Subject: Summary of Public Meeting Between RG&E and NRC Staff Held on August 19, 2003.
R.E. Ginna Nuclear Power Plant
Docket No. 50-244

Control Room Emergency Air
Treatment System (CREATS)
Modification and Alternate Source
Term (AST) Tech Spec Submittal

RG&E Response to Staff Questions

Control Room
Penetration
Flange

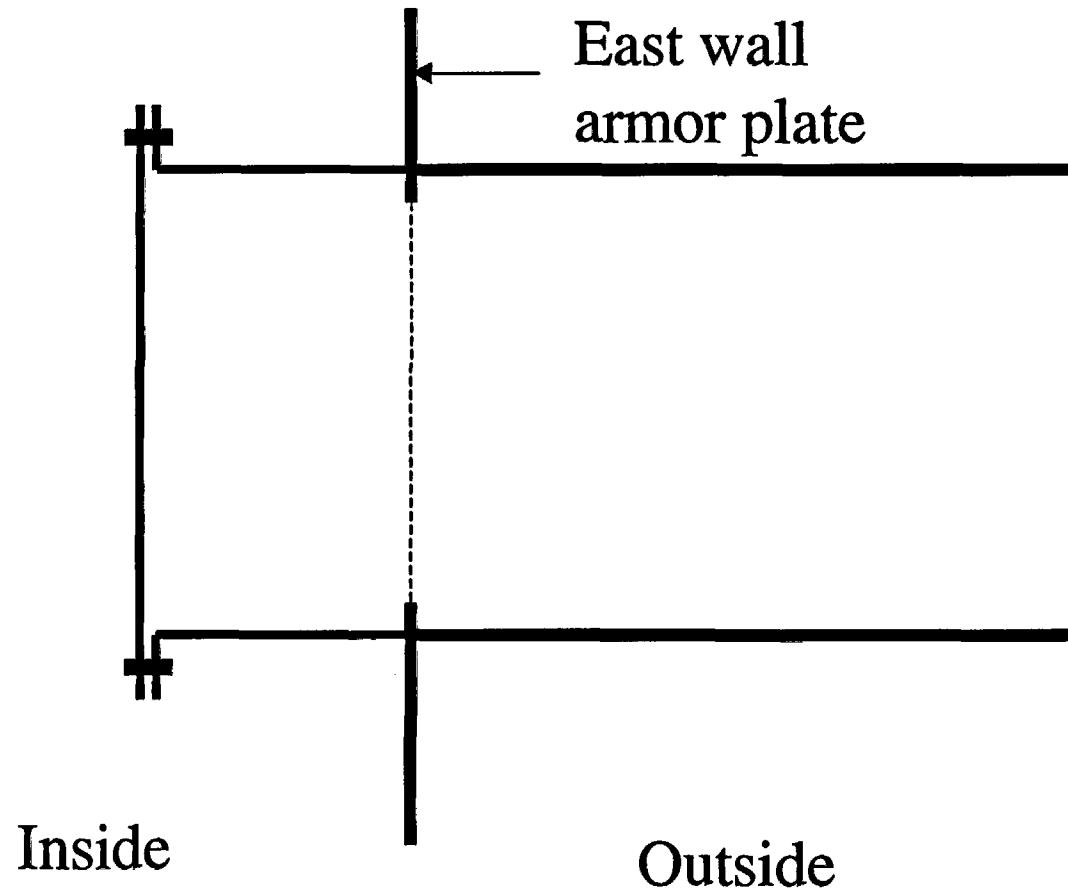
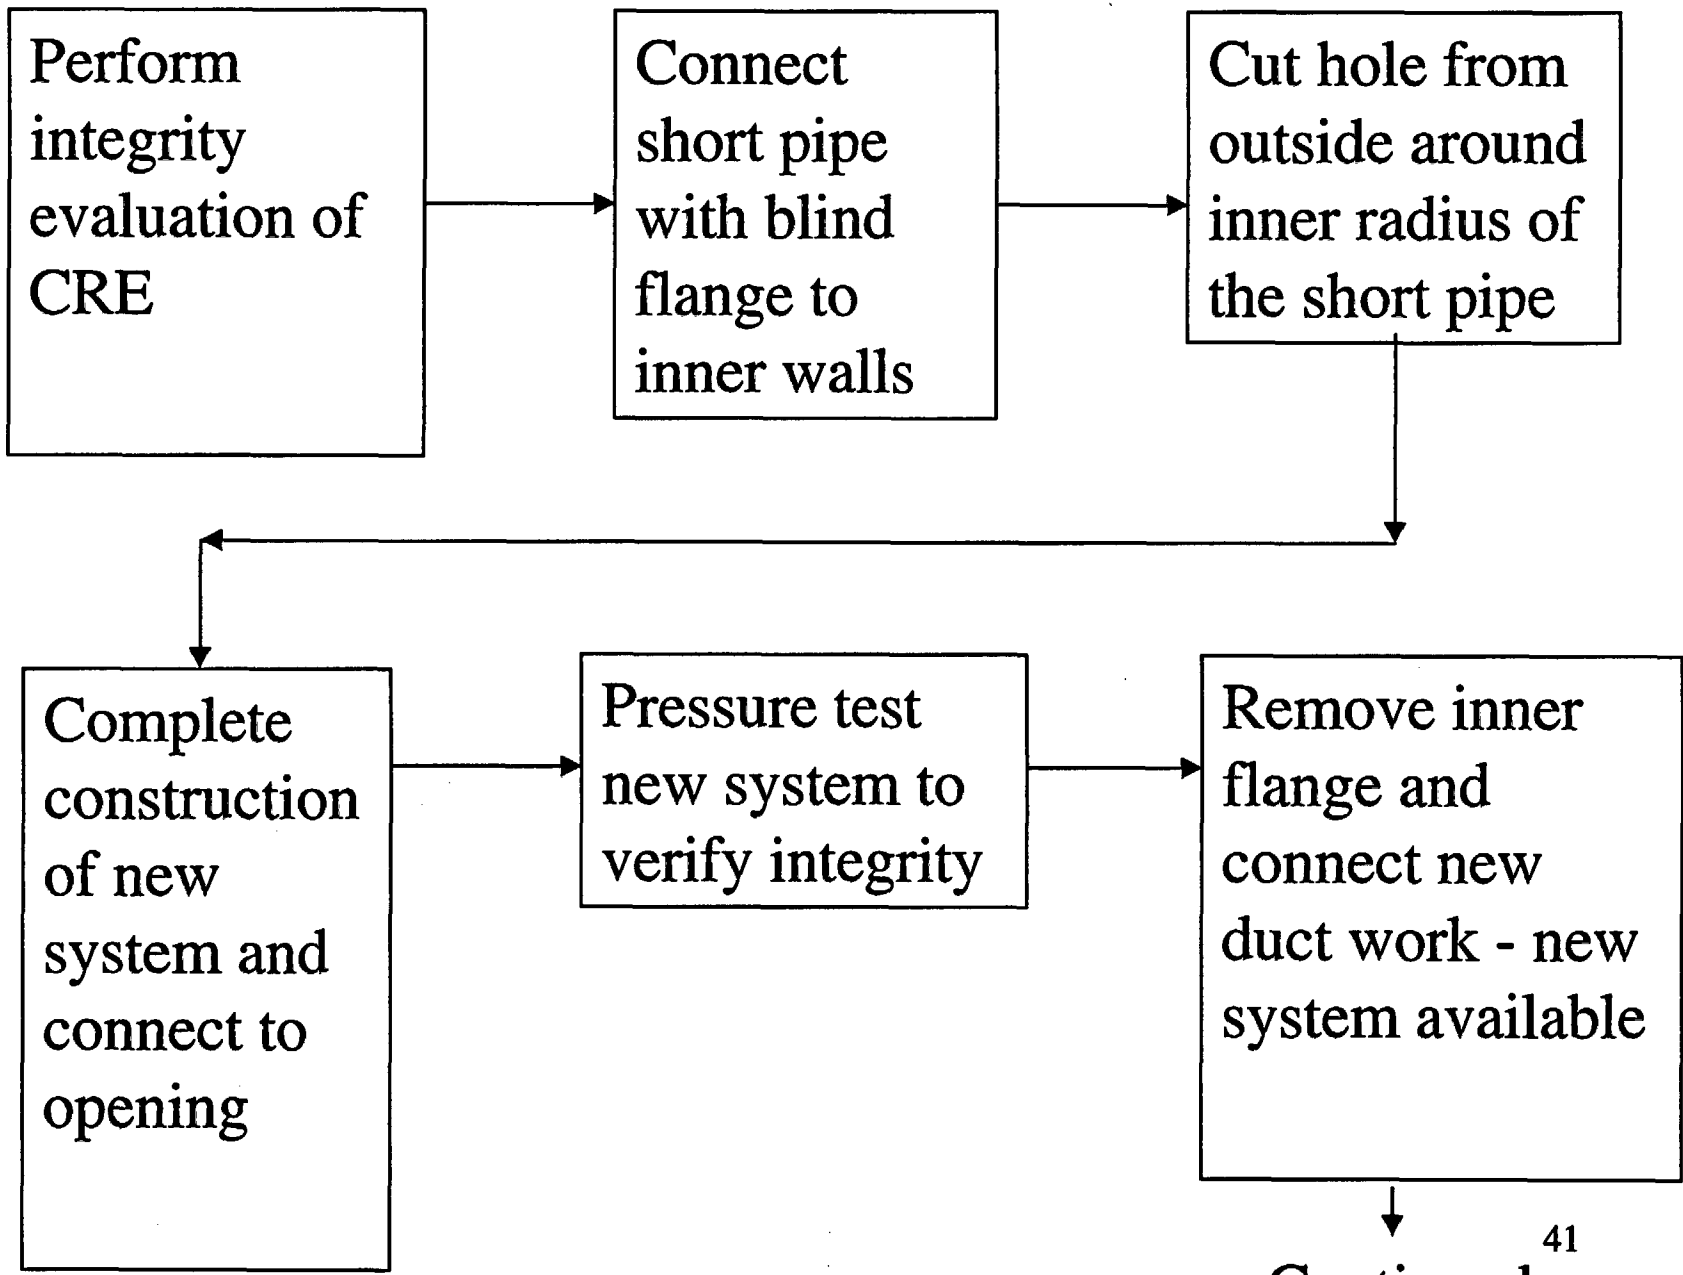
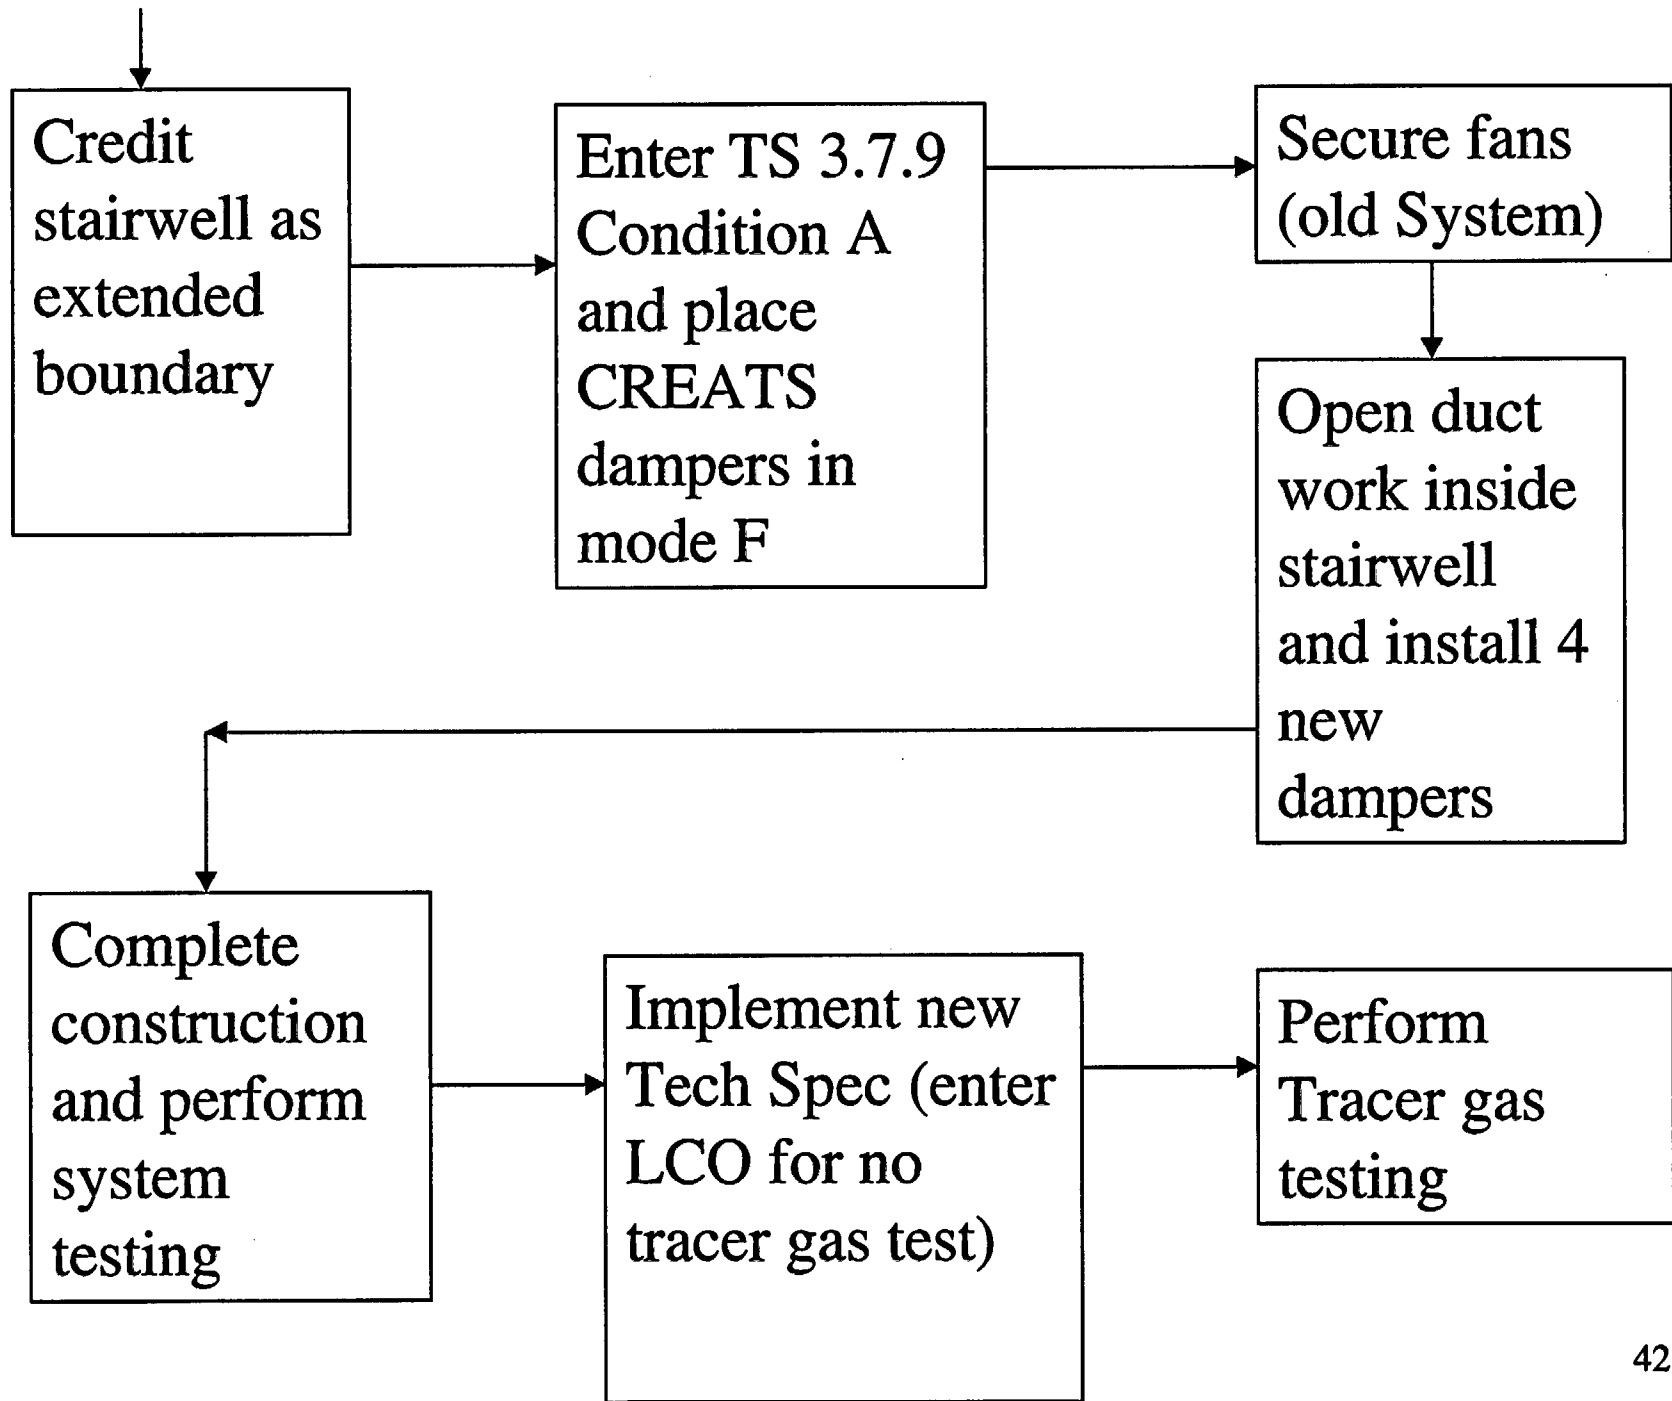
Question - In Section 3.0, “Background” of the submittal, you briefly discussed the procedures for installing the new CREATS during plant operation. Discuss it in more detail with appropriate supporting drawings and figures how you intend to maintain the control room integrity during installation of the new CREATS.

Overview

On-Line Construction Plans
